RECORD DRAWING
BASED ON CONTRACTOR MARKUPS,
NOT FIELD SURVEY.

BW2 JOB NO. 10-1424 AND 11-1471

RECORD DRAWING

WASTEWATER SYSTEM IMPROVEMENTS
WASTEWATER GRAVITY SEWER AND LIFT STATION

WASTEWATER SYSTEM IMPROVEMENTS
WASTEWATER GRAVITY SEWER AND LIFT STATION
LINE "A" - PLAN AND PROFILE
(STA. 0+00 TO STA. 8+00)
CITY OF LUCAS

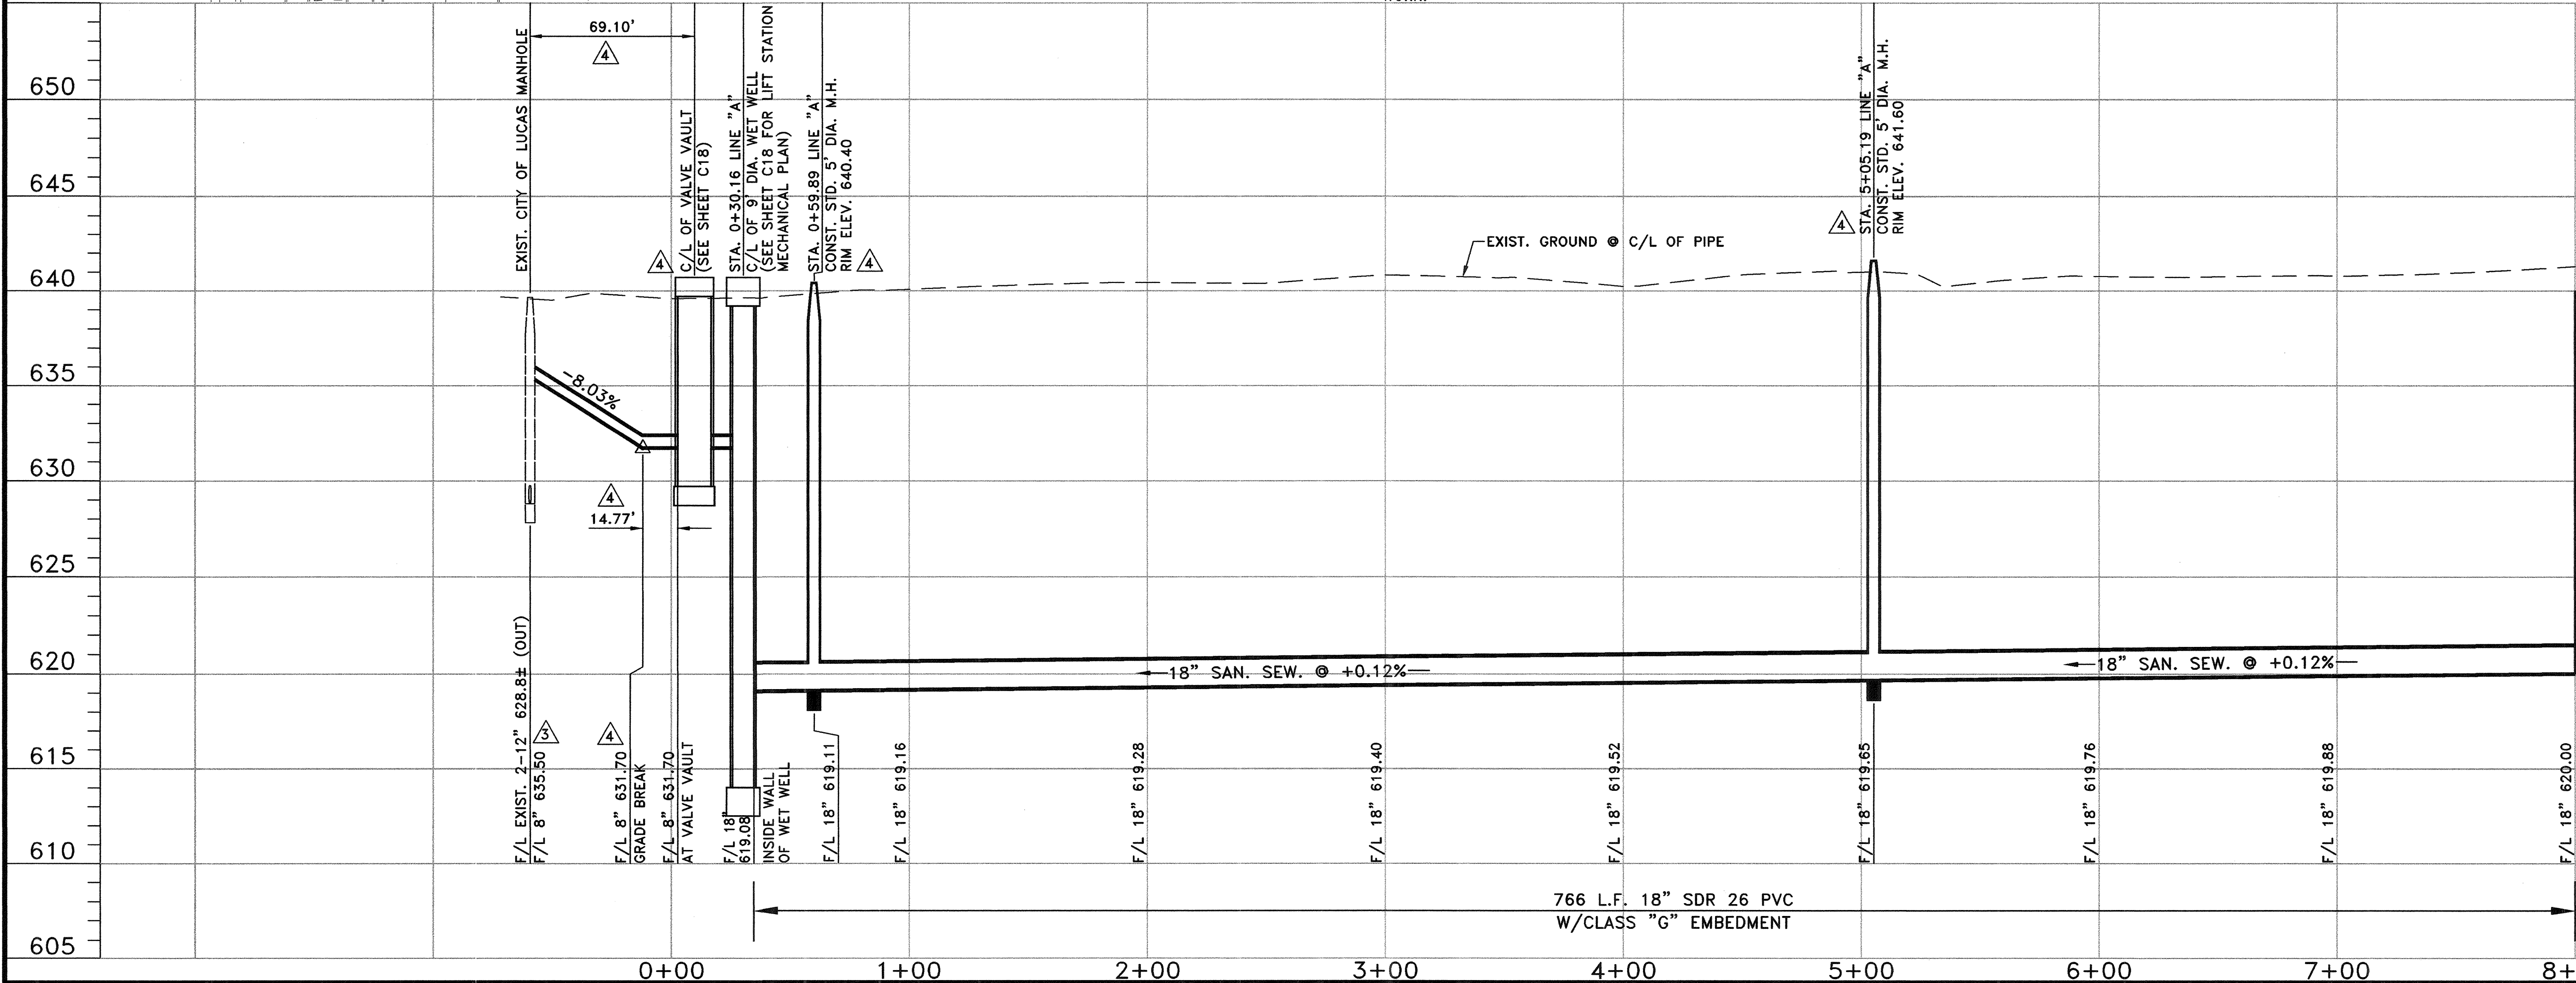
- NOTES:**
1. REVISED THE ELEVATIONS OF THE PROPOSED PIPELINE AND PROPOSED MANHOLES BY LOWERING ALL OF THE ELEVATIONS BY 0.70 FEET.
 2. REVISED THE ELEVATIONS OF THE PROPOSED PIPELINE AND PROPOSED MANHOLES BY LOWERING ALL OF THE ELEVATIONS BY 1.0 FEET BETWEEN THE LIFT STATION AND MANHOLE AT STA. 55+00.00.

5. DELETE NOTE NO. 4 AND REPLACE WITH THE FOLLOWING:
THE FORCE MAIN FROM THE VALVE VAULT SHALL ENTER THE DISCHARGE MANHOLE AT FLOW LINE 635.50. A 90° BEND SHALL BE INSTALLED AND PROPERLY SECURED AT THE END OF THE FORCE MAIN SUCH THAT THE FORCE MAIN TURNS DOWN AFTER IT ENTERS THE MANHOLE. BEND SHALL BE RESTRAINED FOR THRUST RESTRAINT. ALL HARDWARE AND BOLTS USED FOR THRUST RESTRAINT SHALL BE STAINLESS STEEL.

NO.	DATE	REVISION	REVIEWED
6			
10/30/12	ADDED EXIST. SEWER LINE EASEMENT	MRB	
9/17/12	MOVED PROP. SAN. SEW. 10' EAST PER FIELD CONDITIONS	MRB	
7/13/12	REVISED PER ADDENDUM NO. 5	MRB	
7/13/12	REVISED PER ADDENDUM NO. 4	MRB	
7/13/12	REVISED PER ADDENDUM NO. 2	MRB

WASTEWATER SYSTEM IMPROVEMENTS
WASTEWATER GRAVITY SEWER AND LIFT STATION
LINE 'A' - PLAN AND PROFILE
(STA. 26+00 TO STA. 36+00)
CITY OF LUCAS

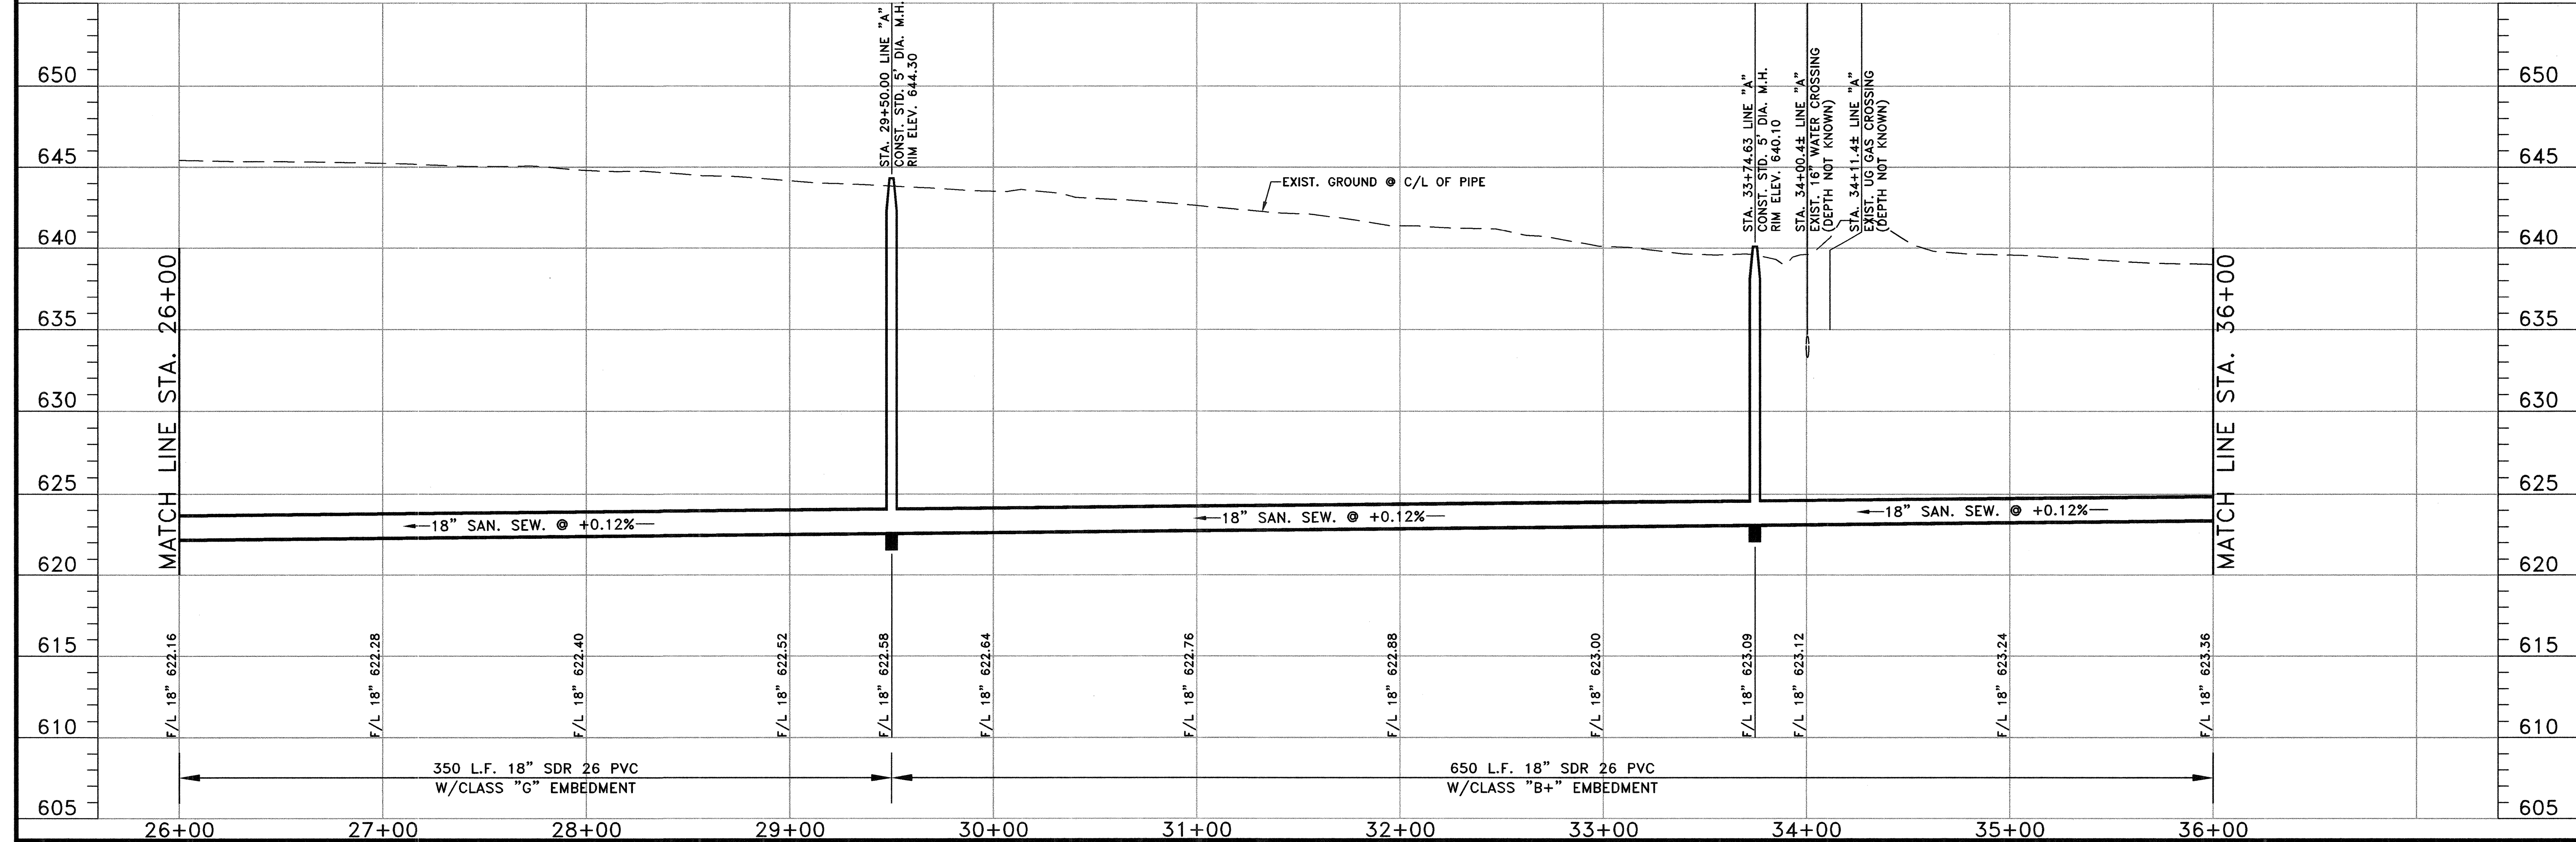
- NOTES:**
1. REVISED THE ELEVATIONS OF THE PROPOSED PIPELINE AND PROPOSED MANHOLES BY LOWERING ALL OF THE ELEVATIONS BY 0.70 FEET.
 2. REVISED THE ELEVATIONS OF THE PROPOSED PIPELINE AND PROPOSED MANHOLES BY LOWERING ALL OF THE ELEVATIONS BY 1.0 FEET BETWEEN THE LIFT STATION AND MANHOLE AT STA. 35+00.00.

WASTEWATER SYSTEM IMPROVEMENTS
WASTEWATER GRAVITY SEWER AND LIFT STATION
LINE A - PLAN AND PROFILE
(STA. 36+00 TO STA. 46+00)
CITY OF LUCAS

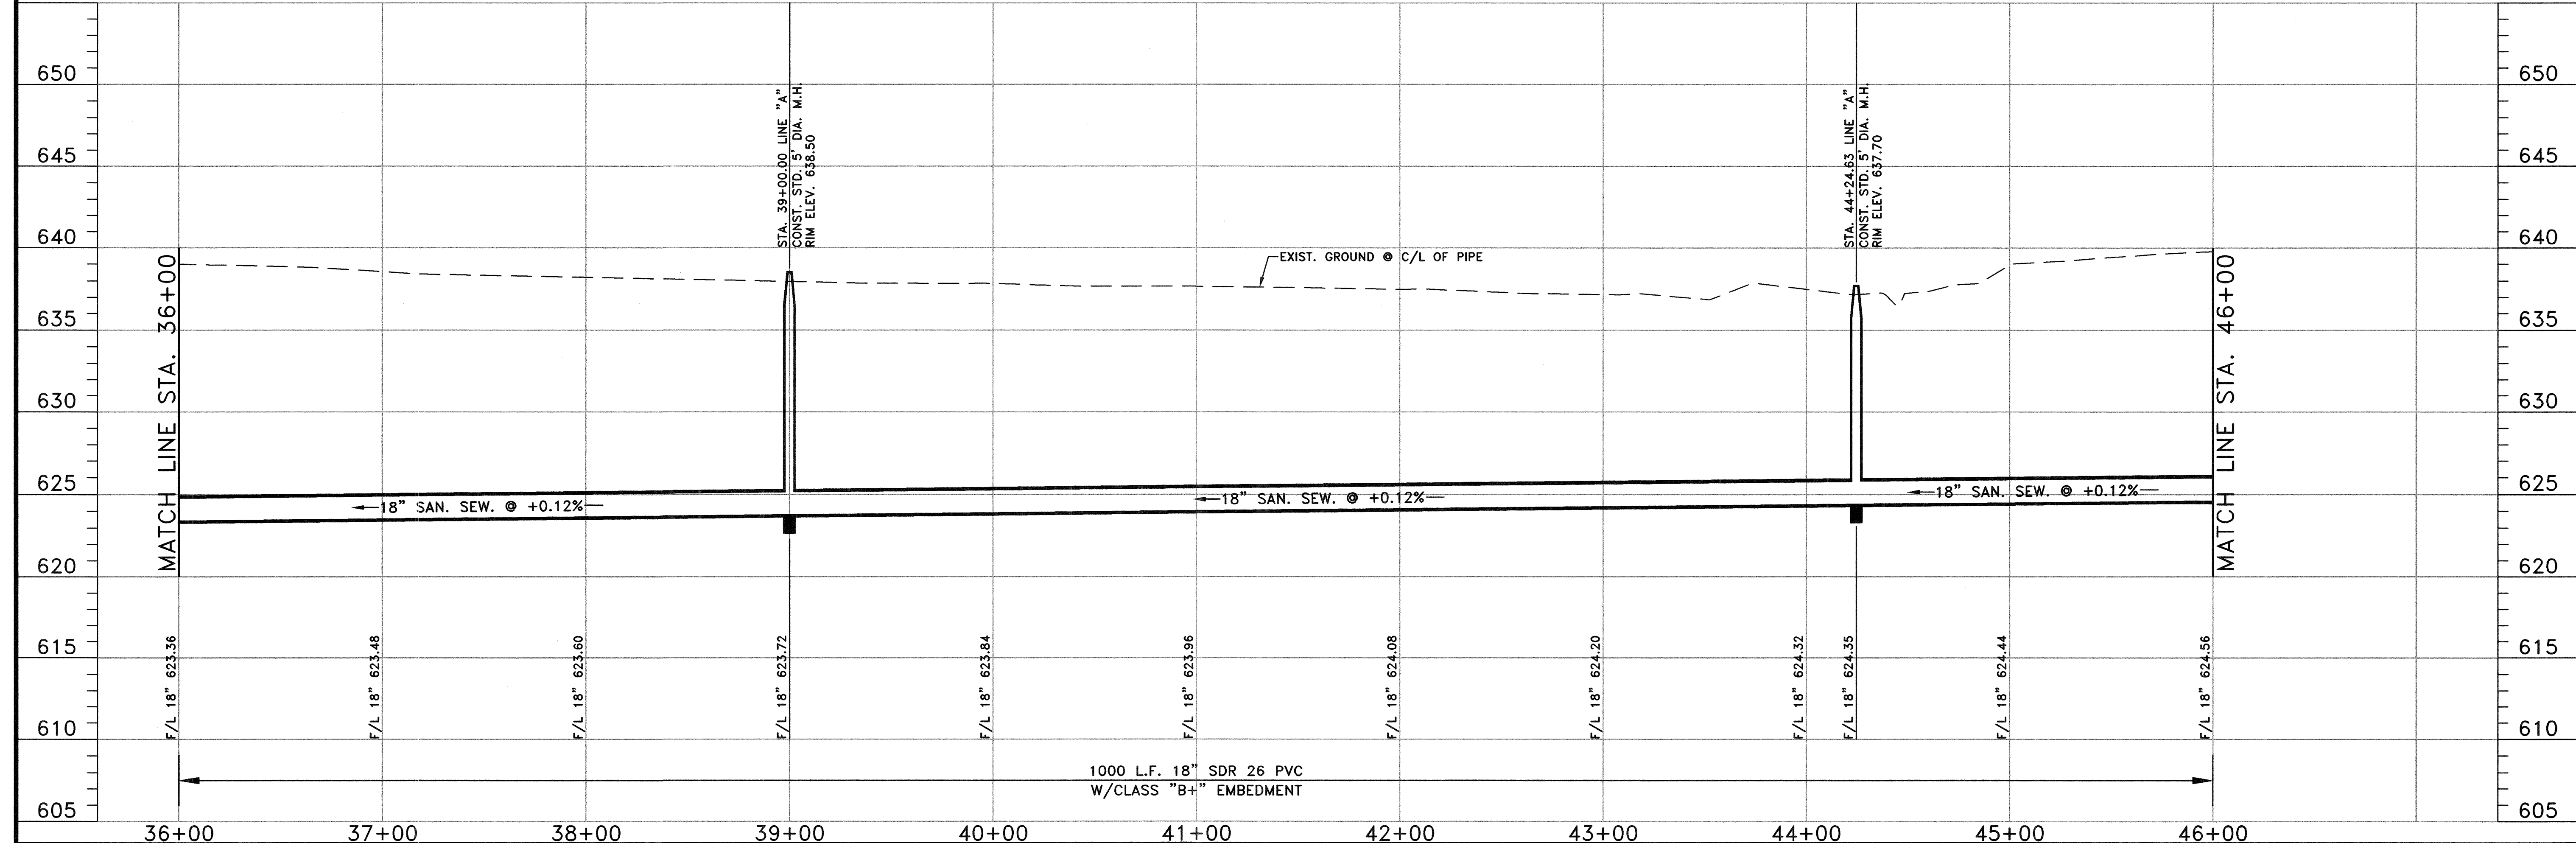
- NOTES:**
1. REVISED THE ELEVATIONS OF THE PROPOSED PIPELINE AND PROPOSED MANHOLES BY LOWERING ALL OF THE ELEVATIONS BY 0.70 FEET.
 2. REVISED THE ELEVATIONS OF THE PROPOSED PIPELINE AND PROPOSED MANHOLES BY LOWERING ALL OF THE ELEVATIONS BY 1.0 FEET BETWEEN THE LIFT STATION AND MANHOLE AT STA. 55+00.00.

3. THE PIPE STIFFNESS FOR ALL THE PIPES SHALL BE A PS OF 115 PSI. WHERE THE COVER OVER THE PROPOSED 18" SANITARY SEWER EXCEEDS 20', CLASS "G" EMBEDMENT (CONCRETE ENCASEMENT) SHALL BE UTILIZED. WHERE THE COVER OVER THE PROPOSED 18" SANITARY SEWER IS 20' OR LESS, CLASS "B+" EMBEDMENT SHALL BE UTILIZED. WHEN THE CONCRETE ENCASEMENT IS BEING PLACED FOR THE CLASS "G" EMBEDMENT, THE CONTRACTOR SHALL PLACE THE CONCRETE ENCASEMENT BY TREMMIE OR SMALL BUCKET; DROPPING CONCRETE ON TOP OF THE PIPE DIRECTLY FROM THE CONCRETE TRUCK CHUTE WILL NOT BE PERMITTED. CONTRACTOR SHALL TAKE ALL MEANS NECESSARY TO MAINTAIN THE CORRECT GRADE ON THE PROPOSED PIPELINE AND TO PREVENT THE PIPE FROM FLOATING WHEN PLACING THE CONCRETE ENCASEMENT. EXCAVATED ROCK FROM THE TRENCH AREA IS NOT A SUITABLE BACKFILL MATERIAL AND SHALL BE HAULED OFF THE CONSTRUCTION SITE AND DISPOSED OF ELSEWHERE. THE COST OF ALL OF THIS WORK SHALL BE INCLUDED IN THE PRICE BID FOR THE ITEMS, AND THERE SHALL BE NO EXTRA PAY FOR ANY OF THIS WORK.

WASTEWATER SYSTEM IMPROVEMENTS
WASTEWATER GRAVITY SEWER AND LIFT STATION
LINE 'A' - PLAN AND PROFILE
(STA. 46+00 TO STA. 56+00)
CITY OF LUCAS

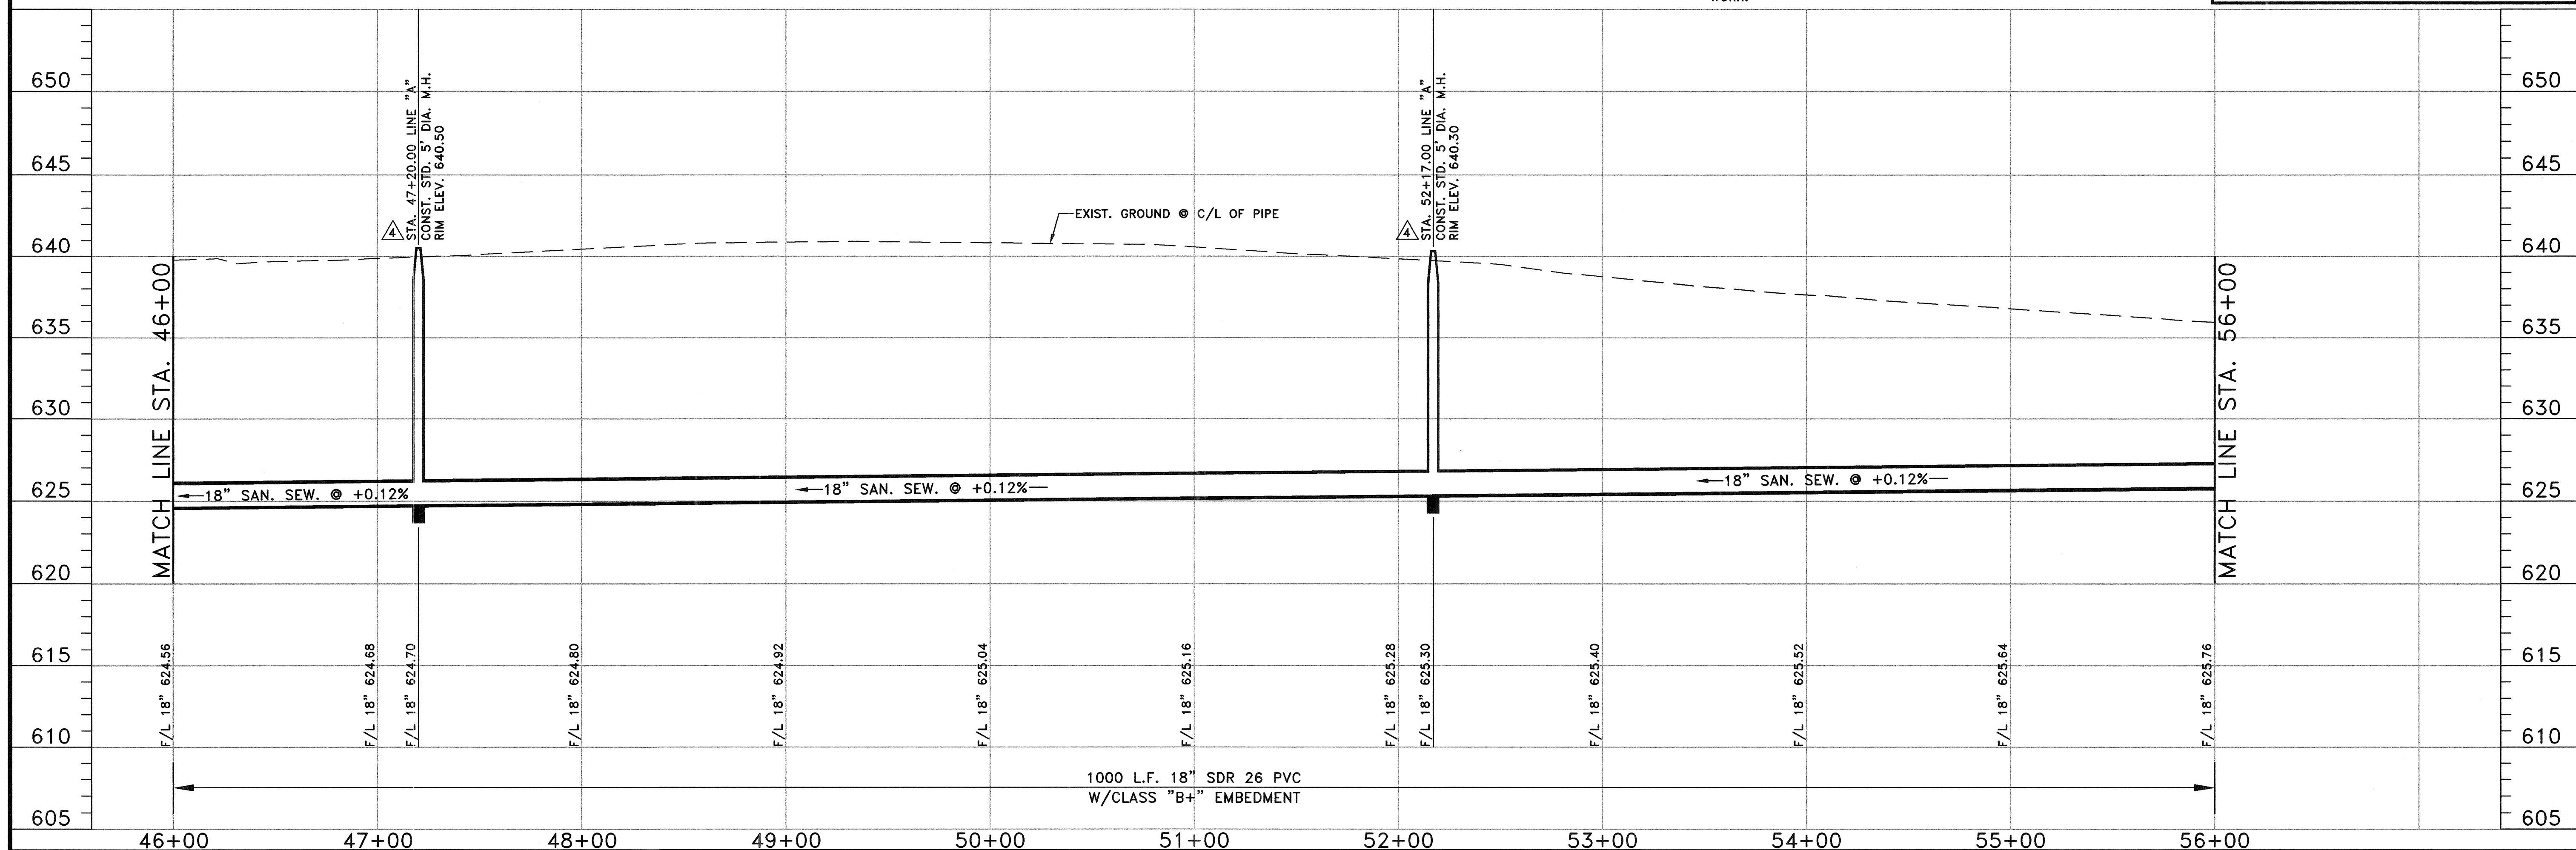
- NOTES:**
1. REVISED THE ELEVATIONS OF THE PROPOSED PIPELINE AND PROPOSED MANHOLES BY LOWERING ALL OF THE ELEVATIONS BY 0.70 FEET.
 2. REVISED THE ELEVATIONS OF THE PROPOSED PIPELINE AND PROPOSED MANHOLES BY LOWERING ALL OF THE ELEVATIONS BY 1.0 FEET BETWEEN THE LIFT STATION AND MANHOLE AT STA. 55+00.00.

3. THE PIPE STIFFNESS FOR ALL THE PIPES SHALL BE A PS OF 115 PSI. WHERE THE COVER OVER THE PROPOSED 18" SANITARY SEWER EXCEEDS 20', CLASS "G" EMBEDMENT (CONCRETE ENCASEMENT) SHALL BE UTILIZED. WHERE THE COVER OVER THE PROPOSED 18" SANITARY SEWER IS 20' OR LESS, CLASS "B+" EMBEDMENT SHALL BE UTILIZED. WHEN THE CONCRETE ENCASEMENT IS BEING PLACED FOR THE CLASS "G" EMBEDMENT, THE CONTRACTOR SHALL PLACE THE CONCRETE ENCASEMENT BY TREMMIE OR SMALL BUCKET; DROPPING CONCRETE ON TOP OF THE PIPE DIRECTLY FROM THE CONCRETE TRUCK CHUTE WILL NOT BE PERMITTED. CONTRACTOR SHALL TAKE ALL MEANS NECESSARY TO MAINTAIN THE CORRECT GRADE ON THE PROPOSED PIPELINE AND TO PREVENT THE PIPE FROM FLOATING WHEN PLACING THE CONCRETE ENCASEMENT. EXCAVATED ROCK FROM THE TRENCH AREA IS NOT A SUITABLE BACKFILL MATERIAL AND SHALL BE HAULED OFF THE CONSTRUCTION SITE AND DISPOSED OF ELSEWHERE. THE COST OF ALL OF THIS WORK SHALL BE INCLUDED IN THE PRICE BID FOR THE ITEMS, AND THERE SHALL BE NO EXTRA PAY FOR ANY OF THIS WORK.

NO.	DATE	REVISION	REVIEWED
6			
5			
4	7/31/12	REVISED MANHOLE LOCATIONS PER FIELD CONDITIONS	MRB
3	7/13/12	REVISED PER ADDENDUM NO. 5	MRB
2	7/13/12	REVISED PER ADDENDUM NO. 4	MRB
1	7/13/12	REVISED PER ADDENDUM NO. 2	MRB
